STAFF RECOMMENDATION 1915 Blair Boulevard October 19, 2016

Application: New construction- detached accessory dwelling unit; Setback determination
District: Belmont-Hillsboro Neighborhood Conservation Zoning Overlay
Council District: 18
Map and Parcel Number: 10416006400
Applicant: Brian Haun, Allard Ward Architects
Project Lead: Melissa Sajid, melissa.sajid@nashville.gov

Description of Project: The request is to construct a detached accessory dwelling unit and includes a rear setback determination to reduce the rear setback from twenty feet (20') to eight feet (8').

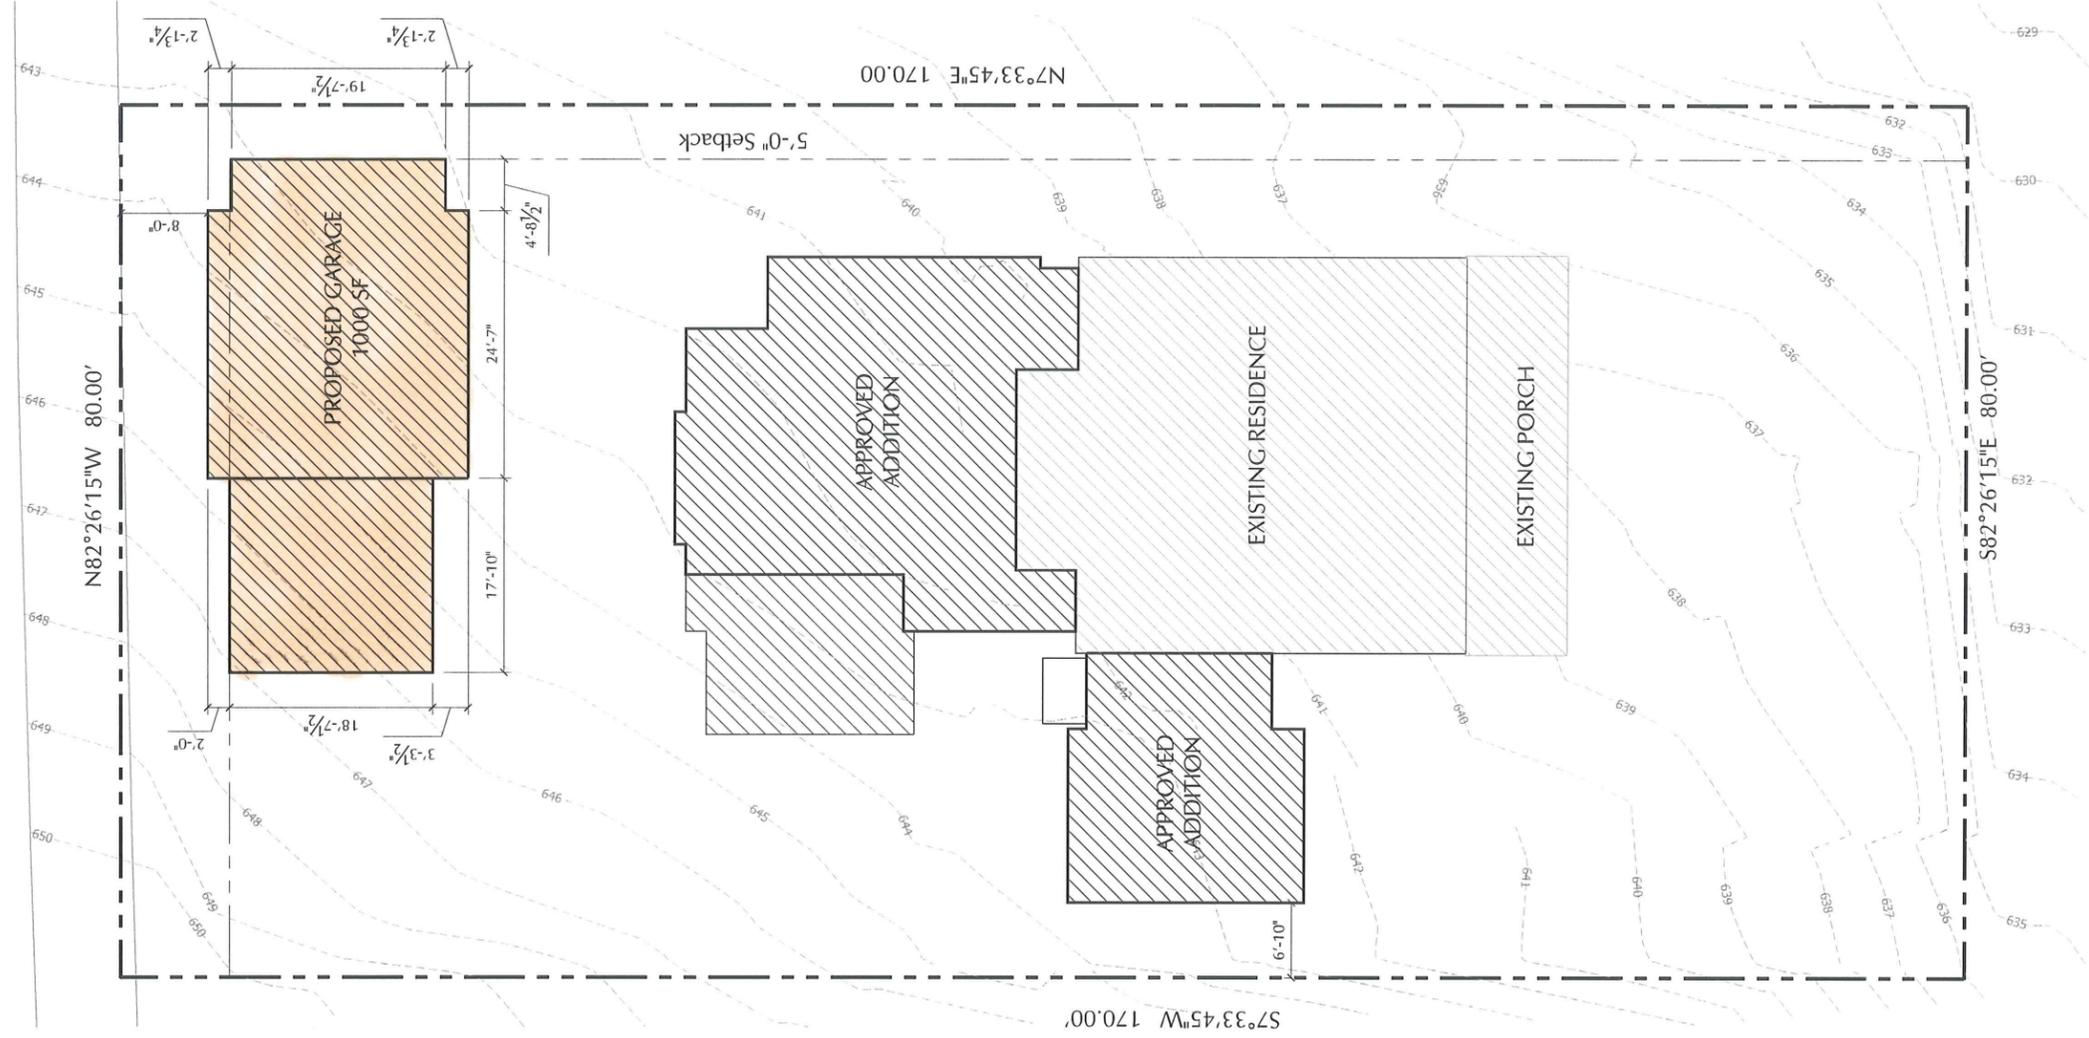
to be measured from finished floor)	measured from grade)	
Ridge Height	25'-2"	25'	24'-10 ¾"
Eave Height	10'-5"	1 story 10'	10'

Lot is greater than 10,000 square feet	50% of first floor area of principle structure	Proposed footprint
Maximum Square Footage	1,000 sq. ft.	1,745 sq. ft.	1,000 sq. ft.

Site Layout Plan

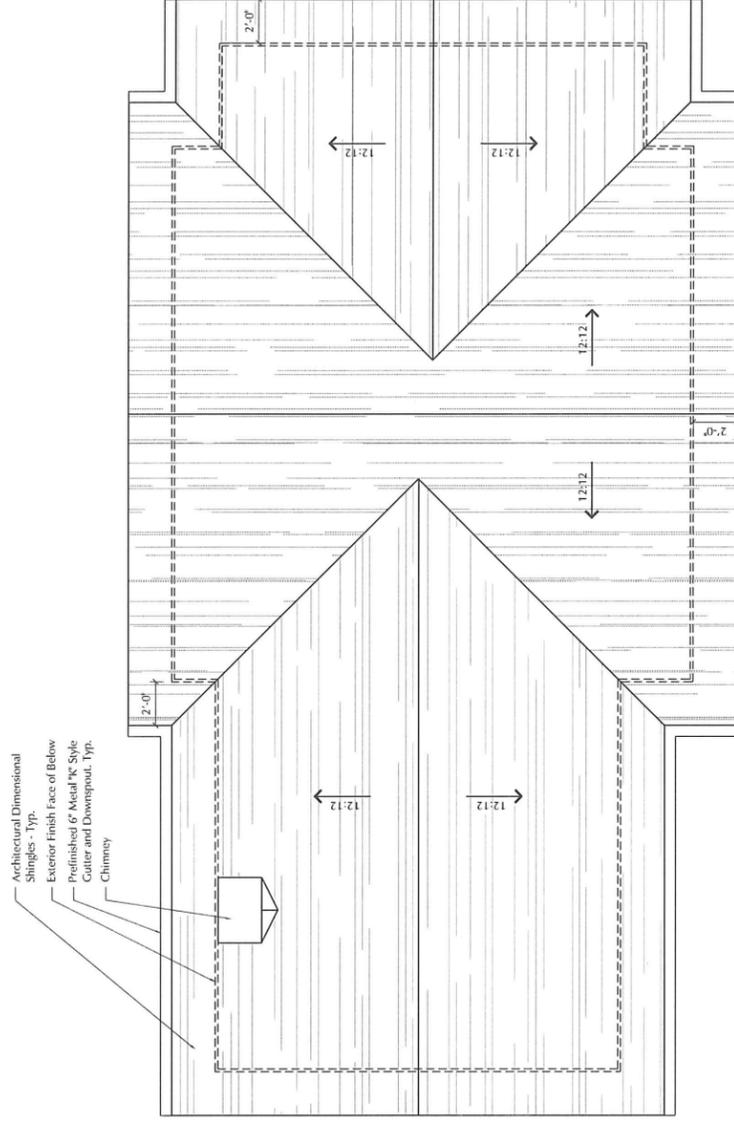
Setbacks: When an outbuilding has a footprint greater than seven hundred square feet (700 sq. ft.), bulk zoning requires that the structure be located twenty feet (20') from the rear property line. In this instance, the structure is located twenty-eight feet (28') from the

left side property line and five feet (5') from the right side property line, but it is located eight feet (8') from the rear property line. Staff finds that the proposed rear setback is appropriate since historically, outbuildings were located at the rear of the property, close to the rear property line. An eight foot (8') rear setback is more historically appropriate than a twenty foot (20') rear setback. Staff recommends approval of the setback determination. The project meets Section II.B.i. of the design guidelines and 17.16.030.G. 4 of the ordinance.

MINIMUM	PROPOSED
Space between principal building and DADU/Garage	20'	19'
Rear setback	20'	8'
L side setback	5'	28'
R side setback	5'	5'
How is the building accessed?	From the alley or existing curb cut	Alley
